Re: MF2300043-01
Senters Assisted Living-Roof-Main Bldg PART A

Job MF2300043-01	Truss A41	Truss Type Attic	Qty 1	Ply 1	Senters Assisted Living-Roof-Main Bldg PART A I62634246 Job Reference (optional)
---------------------	--------------	---------------------	----------	----------	--

REPAIR: BREAK IN WEB 1-20 AT 3-0-0 FROM JOINT 20
REPLACE 1-0-0 OF WEB 2-19 AT JOINT 19
BREAK AT MIDPOINT OF WEB 3-17

Job MF2300043-01	Truss A49	Truss Type Attic	Qty 1	Ply 1	Senters Assisted Living-Roof-Main Bldg PART A 162634247
Job Reference (optional)

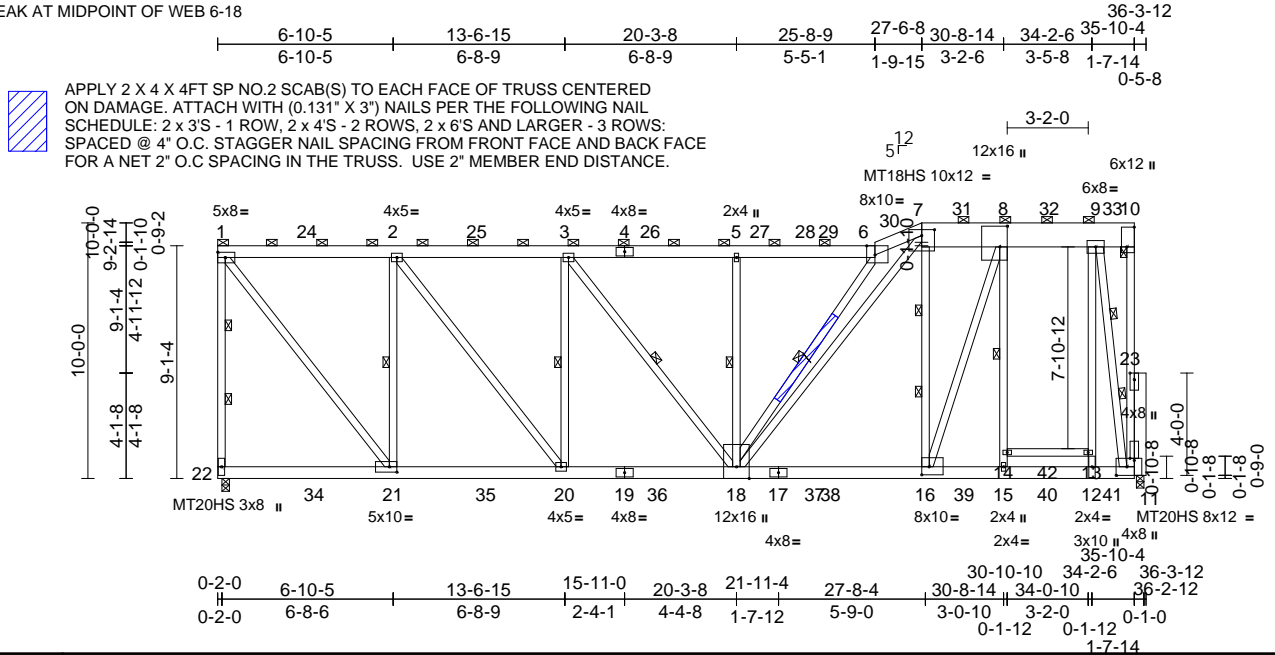
REPAIR: BREAK AT MIDPOINT OF WEB 6-18

Job	Truss	Truss Type	Qty	Ply	Senters Assisted Living-Roof-Main Bldg PART A
MF2300043-01	A04	Attic	14	1	I62634248
Job Reference (optional)

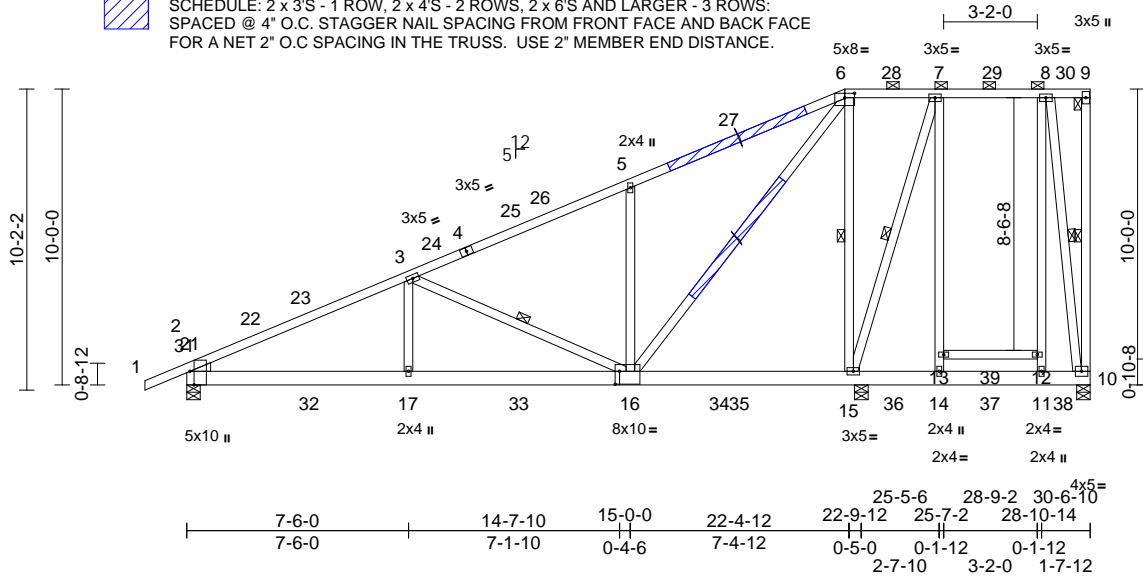
REPAIR: BREAK AT MIDPOINT OF WEB 6-16
BREAK IN TOP CHORD AT 4-0-0 LEFT OF JOINT 6

APPLY 2 X 4 X 5FT SP NO.2 SCAB(S) TO EACH FACE OF TRUSS CENTERED ON DAMAGE. ATTACH WITH (0.131" X 3") NAILS PER THE FOLLOWING NAIL SCHEDULE: 2 x 3'S - 1 ROW, 2 x 4'S - 2 ROWS, 2 x 6'S AND LARGER - 3 ROWS: SPACED @ 4" O.C. STAGGER NAIL SPACING FROM FRONT FACE AND BACK FACE FOR A NET 2" O.C SPACING IN THE TRUSS. USE 2" MEMBER END DISTANCE.
